STRUCTURAL ADDENDUM No 1

September 24, 2024

Re: Renovation To Clarington Fire & Emergency Services Station 1
The Corporation of the Municipality of Clarington
2430 Durham Regional Hwy 2, Bowmanville, ON, L1C 6C8

DRAWINGS S1, S2, S4:

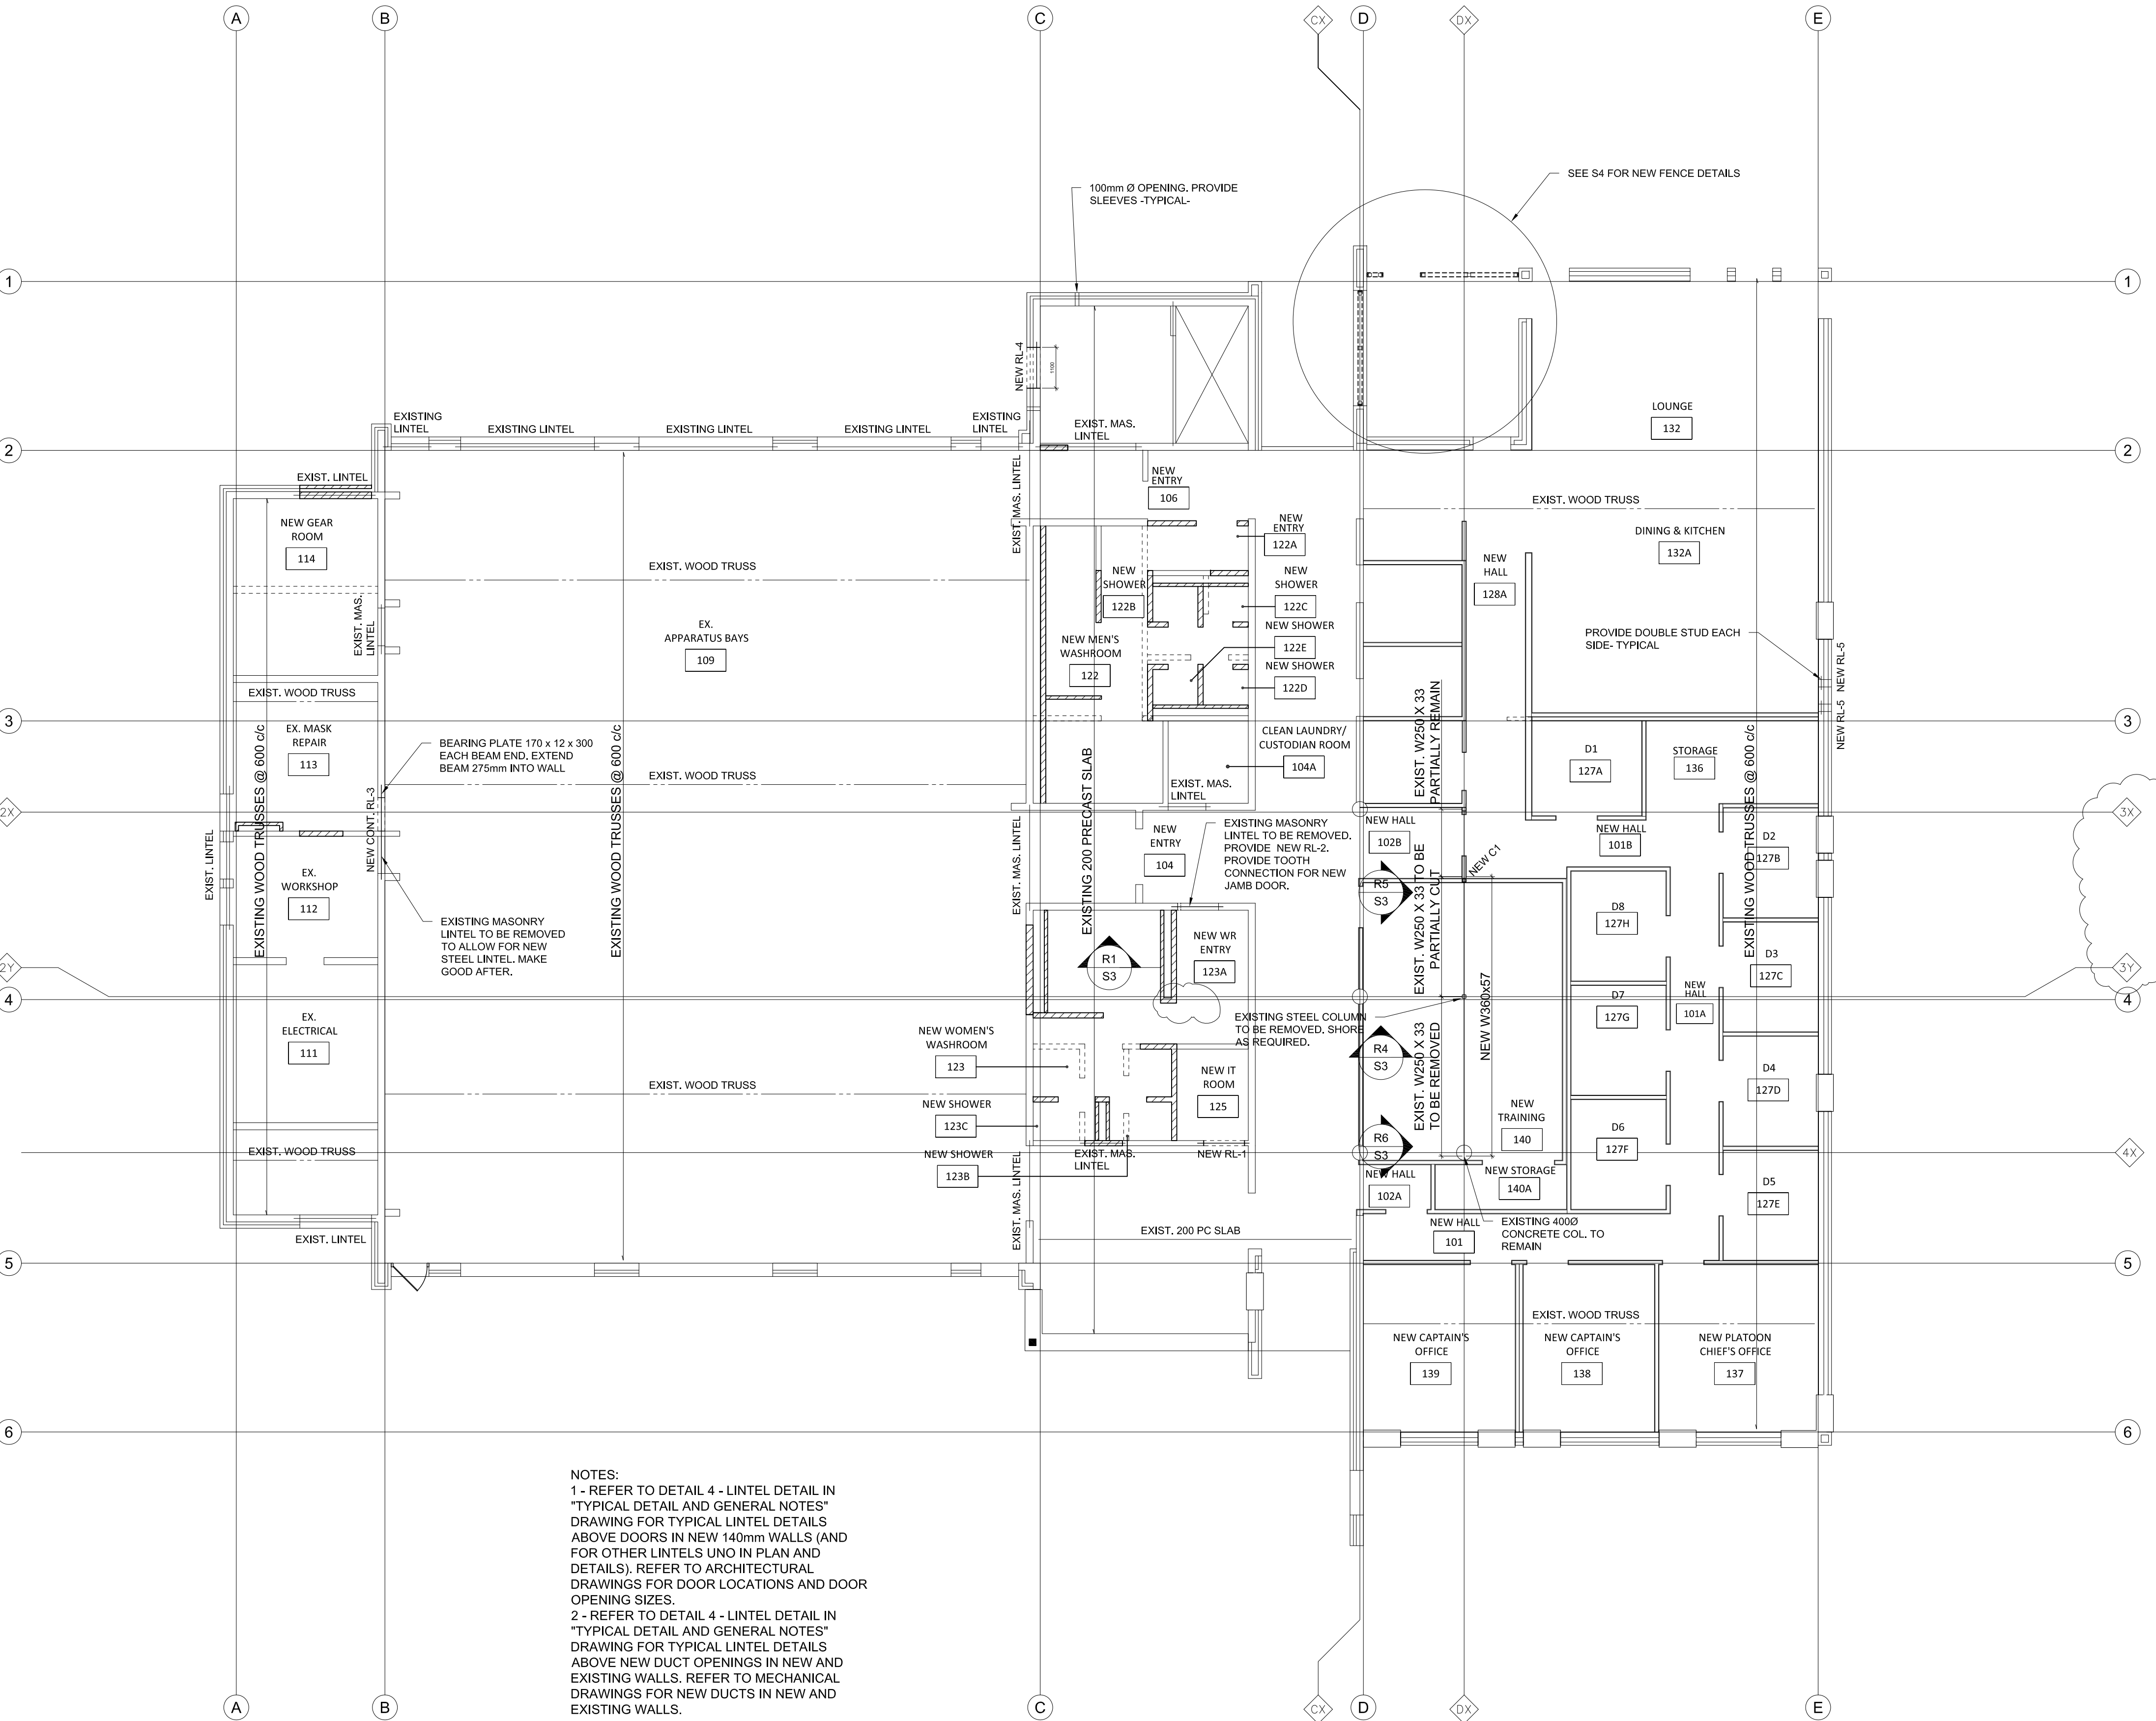
1. Refer to note in the bubble in the typical detail 3/S1. The note is modified to specify that the bars drilled in existing slab to be epoxy grouted.
2. Grids are updated to match architectural drawings. See bubbles in plans 1/S1 and 1/S2.
3. See bubble in 1/S2, close to New WR Entry 123A. The nib wall is removed to match with the architectural drawings.
4. Refer to bubble in the fence details 2/S4, 3/S4 and 4/S4. The type of the epoxy for the drilled bolts is defined in the note. The note is typical and the same for the three sections. Use the described adhesive epoxy or equivalent.
